# Access Compliance Report

## Public Rights-of-Way

Intersection ID: 23481	Main Street: ALEXANDER_RD	Cross Street: PROVIDENCE_RD	Location: NW
ADA ID: AB50CB6111B0	Ramp Type: Perp	Initial Pass/Fail: Fail	Overall Compliance: No
Severity Score: 8.75			
Codes/Mitigation Info/Possible Solution		Field Measurements/Component Compliance

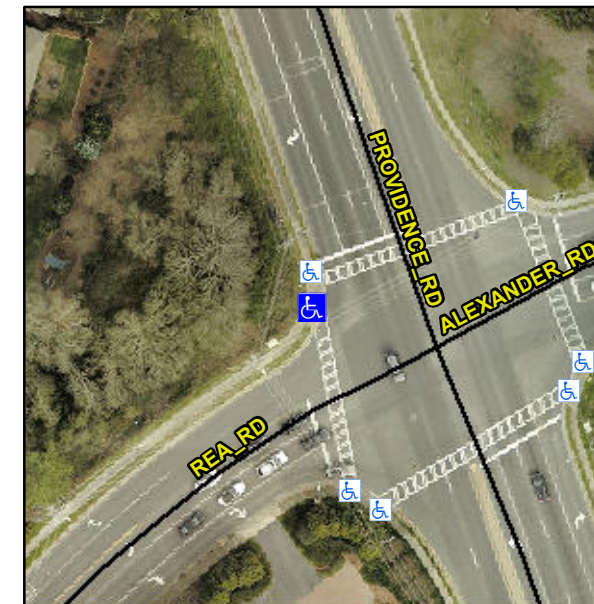
Surveyor Notes:

**N/A**

**Not Found, R304.5.1**

Compliance	Description	Data	Compliance	Description	Data
N/A	Ramp Length (in)	97.0	Yes	Ramp Slope (%)	6.3
No	Ramp Width (in)	42.0	Yes	Ramp XSlope (%)	0.8
N/A	Flare Type LT	N/A	N/A	Flare Type RT	N/A
N/A	Flare Slope LT (%)	N/A	N/A	Flare Slope RT (%)	N/A
N/A	Flare Traversable LT?	N/A	N/A	Flare Traversable RT?	N/A
N/A	Landing Length (in)	N/A	N/A	DWS Provided?	N/A
N/A	Landing Width (in)	N/A	N/A	DWS Contrast?	N/A
N/A	Landing Slope (%)	N/A	N/A	DWS Length (in)	N/A
N/A	Landing X Slope (%)	N/A	N/A	DWS Full Width?	N/A
N/A	Landing Curb? (Y/N)	N/A	N/A	DWS Offset (in)	N/A
N/A	Shared Landing?	N/A			
N/A	Gutter Ponding?	N/A	N/A	Gutter Slope (%)	N/A
N/A	Gutter Lip Ht (in)	N/A	N/A	Gutter X Slope (%)	N/A
N/A	Painted X Walk1?	Yes	N/A	Painted X Walk2?	N/A
	X Walk 1 Direction	To S		X Walk 2 Direction	N/A
N/A	X Walk 1 Width (in)	69.0	N/A	X Walk 2 Width (in)	N/A
	X Walk 1 Slope (%)	1.0		X Walk 2 Slope (%)	N/A
	X Walk 1 X Slope (%)	2.8		X Walk 2 X Slope (%)	N/A

**Remove & Replace Entire Ramp.**
